Title: 6 Channel CT Sensor Meter

Size: A4	Date: 2024-01-20	**Rev: 2.1**
KiCad E.D.A. kicad 7.0.5-7.0.5~ubuntu20.04.1		Id: 1/4

Sheet: /
File: ct_meter.kicad_sch

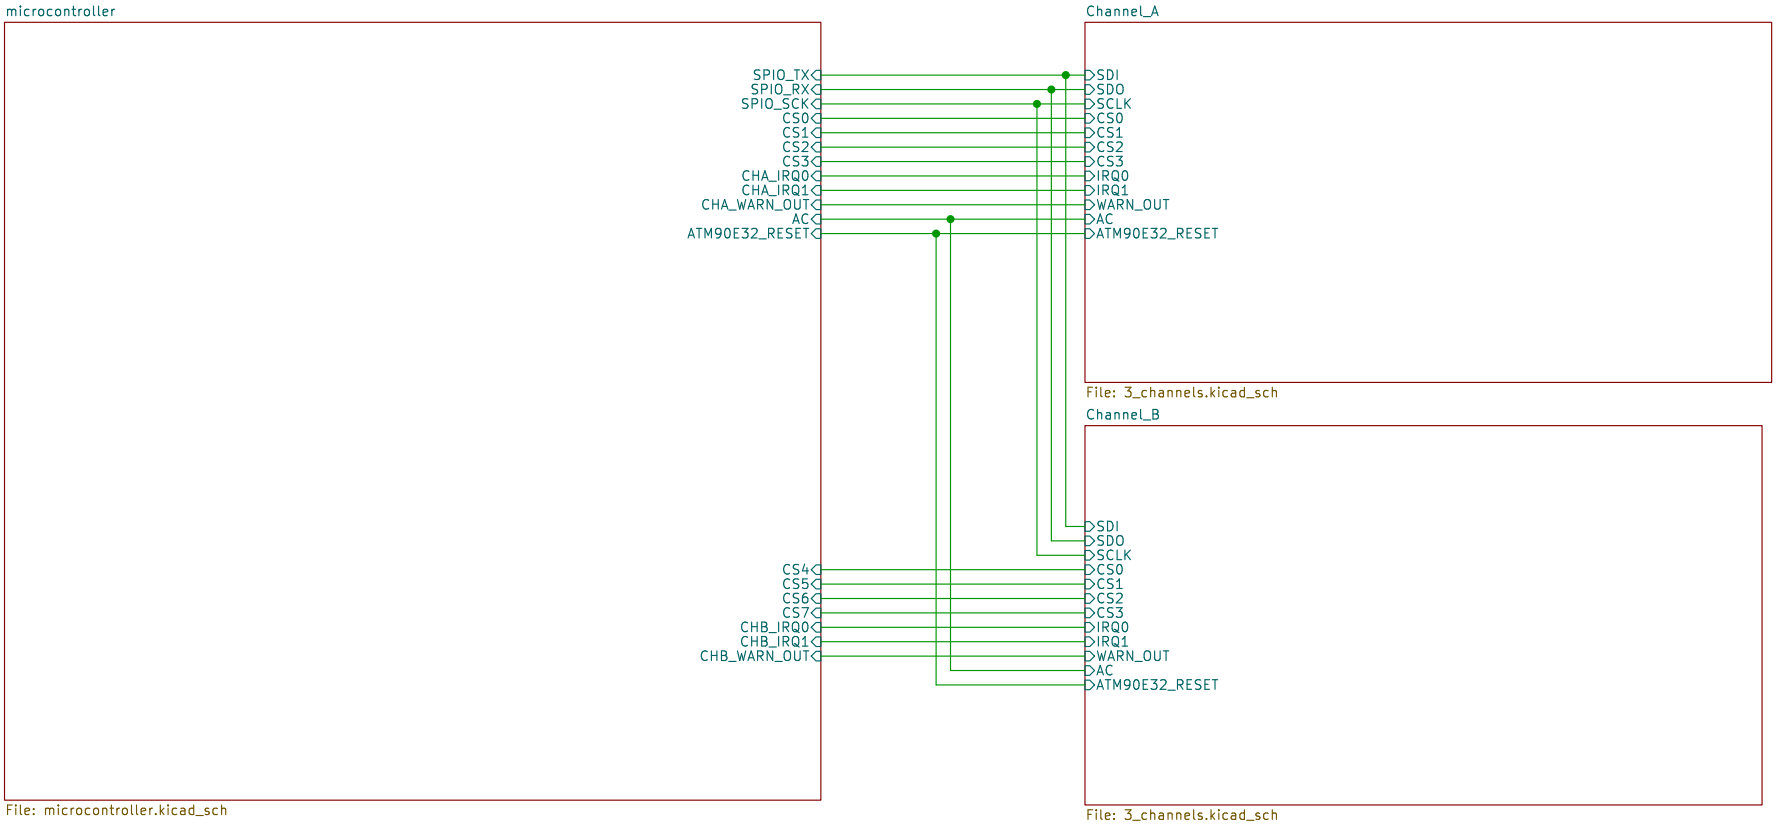
PCB Changes
2.0 – 2.1
– Connected an MCU GPIO (19) pin to reset ATM90E32 devices.

1.9 – 2.0
– 1.2mm DC power connector pin holes are now all the same size.
– Added a jumper on the PCB to allow the voltage offset to be calibrated if required.

1.8 – 1.9
– Added ability to power down the display to save power.

1.7 – 1.8
Changes thermal reliefs to ease soldering during MFG.
